VIN Stamping in Trunk – Revised Location

MODEL 1996 MY-ON  
Sedan Range  
VIN  
764048-ON

ILLUSTRATION 1

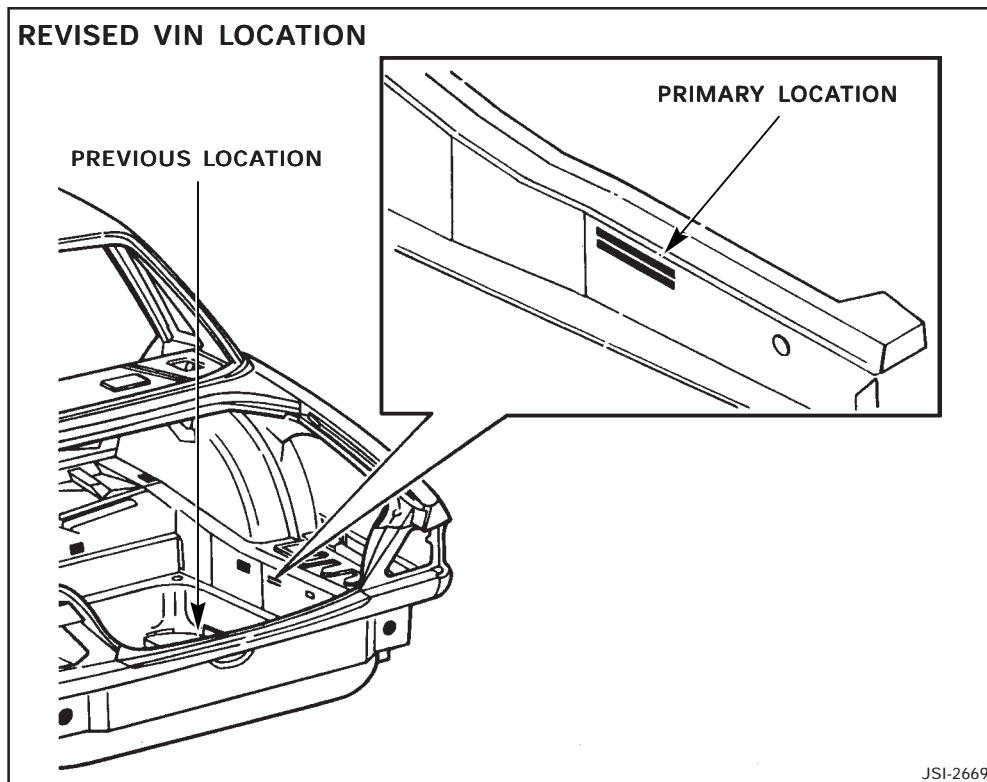
The location of the VIN stamping in the trunk was changed starting with VIN 764048.

The number was previously stamped on the area of the floor between the battery and the spare tire. The revised location is on the vertical face, adjacent to the battery.

The primary location for the VIN is shown in Illustration 1. A secondary location is available in the event the primary stamping needs to be obliterated during vehicle production.
